**Assessment of and Protection Recommendations
For 28 Trees Indicated in
Applicant's Third Party Arborist Report
(by Calyx Tree + Landscape Consulting, aka "Calyx", Dated 11/30/2023)**

**101 S. Santa Cruz
Los Gatos, California**

Report by CTA
3/30/2024

4.4 (TPZ FENCING ISSUES CONTINUED)

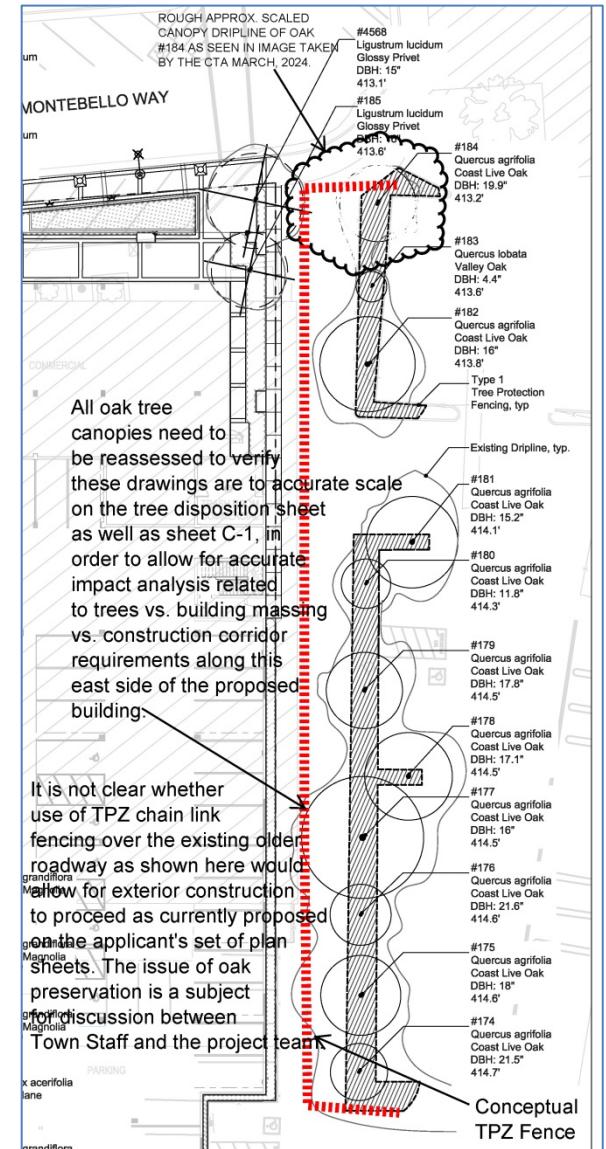
4.4 TREE PROTECTION ZONE (TPZ) FENCING: Applicant's arborist shall indicate tree protection zone (TPZ) fencing layout for chain link protective fencing, on the grading and drainage plan sheet C-1 for better clarity for the project team. Note that fencing as currently shown, at the edges of the existing Monte Bello parking lot curb and planter edges, are not expected to be adequate in terms of protecting tree canopy live wood and foliage against physical damages potentially caused by machinery, vehicles, material movement, personnel, etc. during the proposed project demolition and build periods. Fencing may need to be bumped out into the existing driveway to allow for better protection of oak canopy biomass (see marked up snippet below for an example of how this would appear). It is not known whether chain link TPZ fencing erection at this adjusted location would be feasible, as it may impede normal construction and demo activities to some degree (subject for discussion between project team and Town Staff).

Conceptual TPZ chain link fence line shown as a red dashed route for discussion purposes.

Once the applicant's team redraws the oak tree canopies to corrected scale to verify the relationship between building massings, tree canopies, etc., we can further discuss the issue of how we are going to preserve the oaks while allowing construction to occur.

4.4.1 CONSTRUCTION CORRIDOR CONCEPTUAL SHOWN BY THE CTA IN MAGENTA HIGHLIGHT:

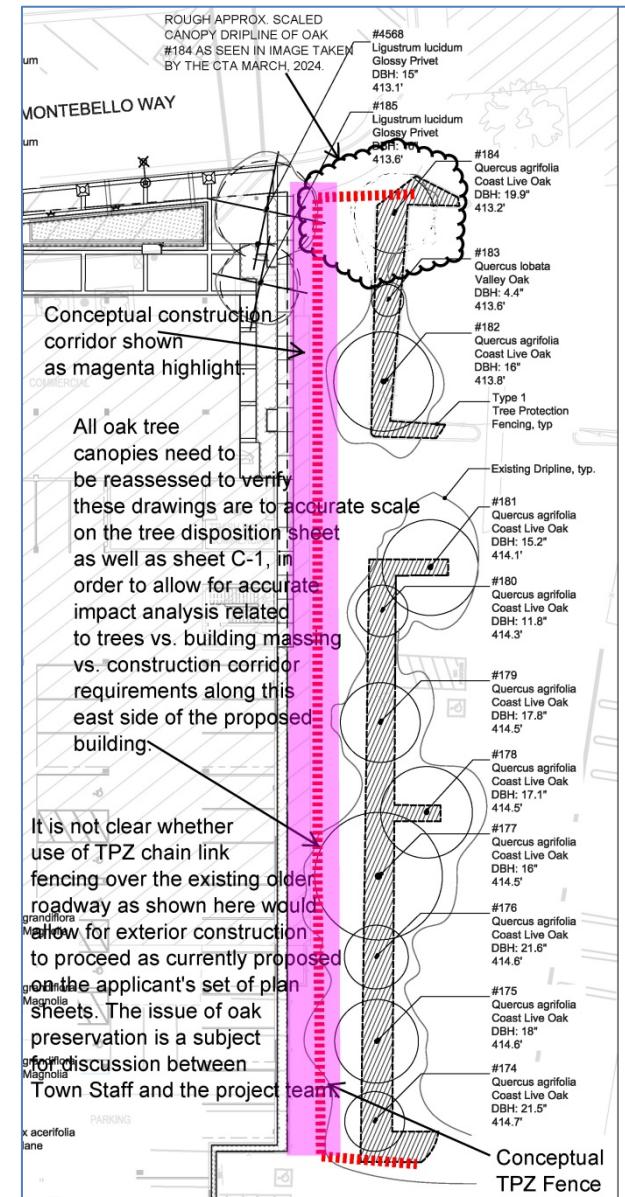
Right: CTA's conceptual rendering of a "construction corridor" scaled to show width of potential extent of such an area required by the applicant's build team, that will assumedly be required for the team to build out the exterior portions of the proposed building massing as currently proposed on applicant plan sheets. Construction corridor is conceptually shown in magenta highlight for easy reference.

It is important to note that the corridor is in direct conflict with oak tree canopy driplines and the TPZ fence route itself, if the fencing were to be erected at the canopy driplines of the trees as currently rendered by The Guzzardo Partnership.

Note also that the applicant's sheet L5.0 used as basis for this markup by the CTA will have to be redrawn to show canopies to accurate scale, since the CTA already identified that at least one tree #184 exhibits canopy that is 100% longer in horizontal extension westward than currently rendered on the drawing (using scale bar indicated on sheet L5.0 by The Guzzardo Partnership TGP).

Once the tree canopies are redrawn by TGP to more accurate scale, the applicant team shall then be required to determine where TPZ fencing will be placed to optimize preservation of the tree canopies, and how wide the "construction corridor" will be in terms of horizontal reach beyond the east side of the proposed residential building exterior.

12.0 Attached: Tree Disposition Plan Sheet L5.0 by Guzzardo Partnership 3/20/2024

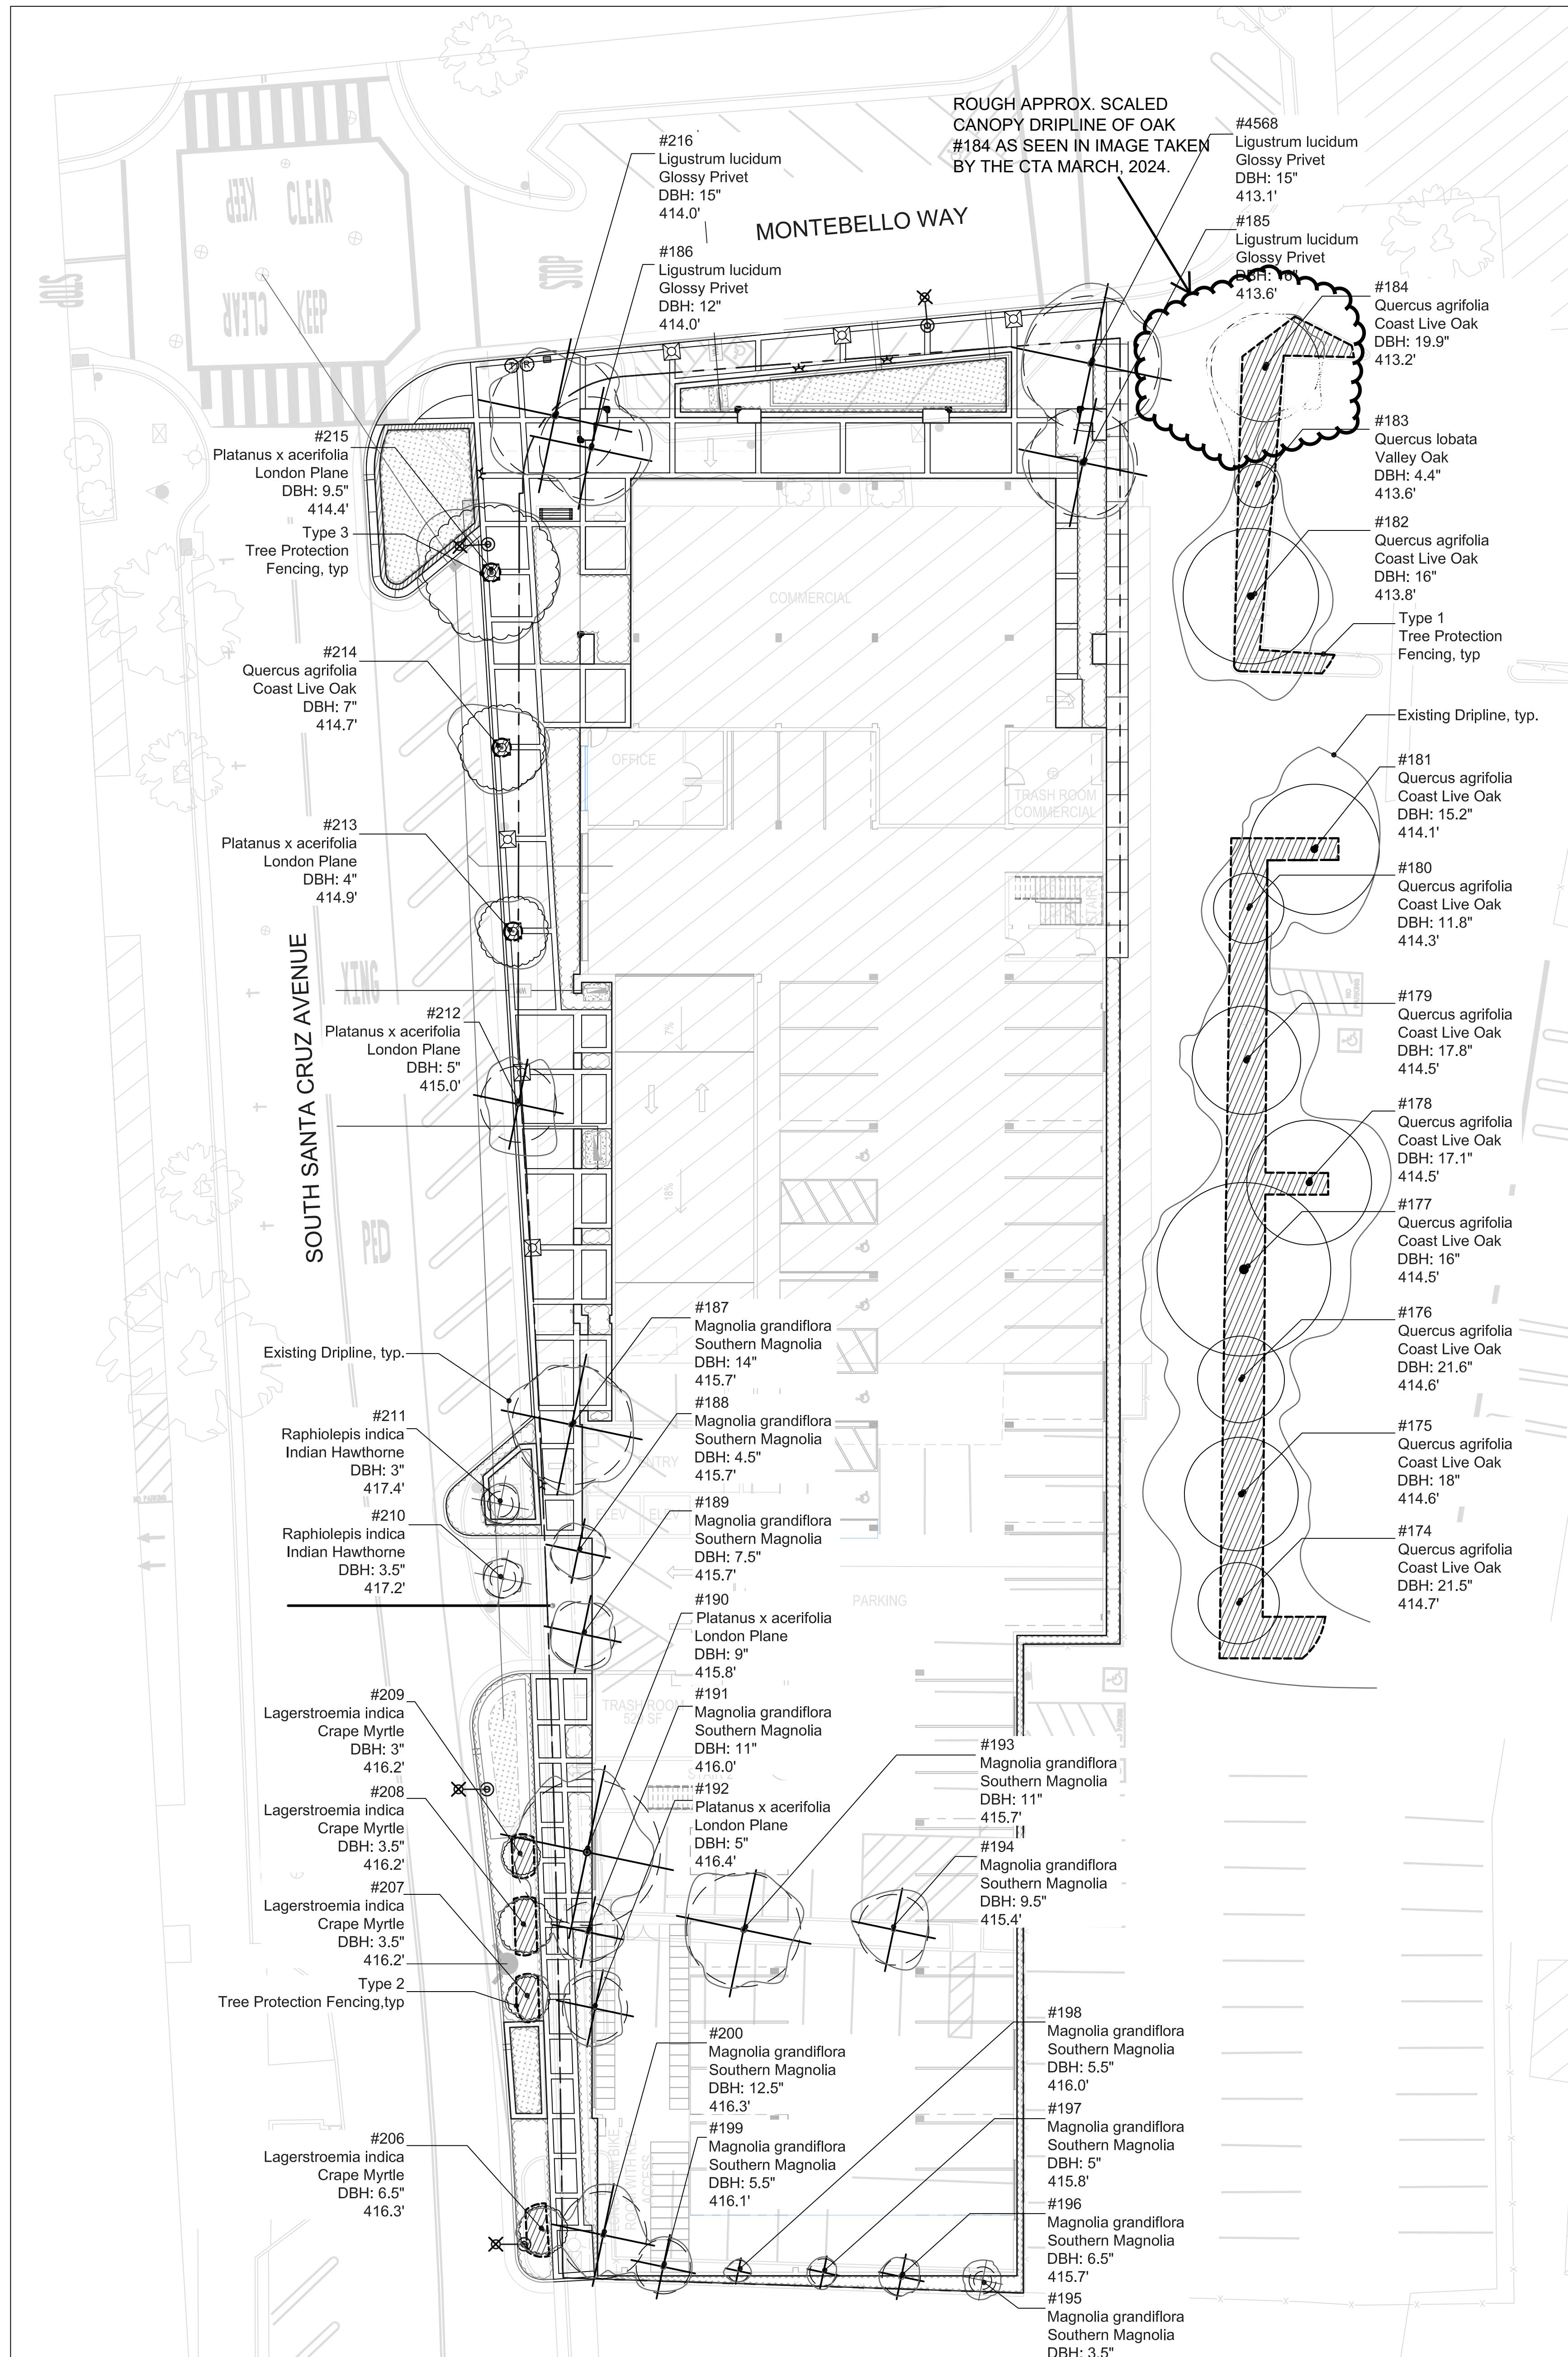
Tree disposition plan sheet L5.0, for instance, shows tree #184 as a 9 foot canopy radius tree, whereas in reality, the tree has a +/- 20 foot radius in the direction of project build, putting it into potential conflict with proposed construction as well as machinery that will be used during exterior finish work such as bucket lift machines, etc. within the assumed 5 to 10 foot wide "construction corridor". See snippets from sheet L5.0 below, showing tree #184 as it appears on sheet L5.0, with an incorrectly scaled canopy. WLCA indicates the actual scaled canopy in markup at right. The entire row of oaks needs to be completely catalogued and shown accurately to scale on all project plan sheets, in order to identify all areas of potential conflict with the proposed building exterior walls, and assumed 5 to 10 foot wide required "construction corridor" along the east side of the proposed building and all construction expected to occur within the limits of work as defined by the project team.

Sheet L5.0 does contain the full analysis of the required tree canopy replacement, which was calculated by TGP as 46 count 24" box size trees, and 2 count 36" box size trees, for a total of 48 trees, which is slightly incorrect as noted below. Sheet L5.0 also notes that the proposed planting plan ("Planting Legend") per TGP on applicant sheet L3.0, included below as a plan sheet snippet in this recommendations section of the CTA report, will include 53 count 24" box size trees, which would appear to satisfy the Town's tree canopy replacement requirement of 51 total trees. However, there are a number of errors and oversights in the sheet L3.0 calculations by TGP as indicated below.

4.6iv The CTA's count of Town-required on-site canopy replacement planting mitigation is actually 51 count 24" box size trees (not the 46 or 48 count as indicated on the "Planting Legend" on TGP's sheet L3.0 version March 2024). This is a small discrepancy, not considered significant, since the total number of 24" box size trees proposed by the project team is already at 51 or 53 count 24" box size trees. The CTA's calculation of required replacement plantings only accounted for removal of trees that measure 4.0 inches diameter each, or greater. All trees less than 4.0 inches diameter were eliminated from the calculation. See Summary Table 1.0a in the summary section of this CTA arborist report for details regarding every single tree in the Calyx study.

4.2.1 OAKS #174 THROUGH #184 CANOPY DRIPINES NOT INDICATED TO SCALE ON SHEET C-1 ETC: Applicant team shall redraw the canopies of trees #174 through #184 to correct scale on applicant grading and drainage plan sheet C-1 and other proposed plan sheets in the set of plans submitted for Town review dated 3/20/2024. The grey line clouding indicated on sheet C-1 and other sheets which was intended by the applicant to show the canopy driplines for these oaks in the Monte Bello parking lot do not appear to be entirely accurate in terms of showing correctly-scaled canopy overhang into the proposed project buildout (limit of work).

Applicant team shall show a highlighted band of color along the side of proposed project exterior facing the row of oaks #174 through #184, to indicate the area where a construction corridor of 5 to 10 feet width will need to be created along the proposed east side of building. If this corridor conflicts with the corrected/scaled canopy driplines of the oaks (once the project team redraws the canopies of these 10 trees to scale on the plan sheets), then the applicant will need to describe in detail the specific mitigation measures required to be performed by the project build team in order to reduce or eliminate conflicts between the oak canopy driplines and the proposed construction corridor along the east side of the proposed building exterior.
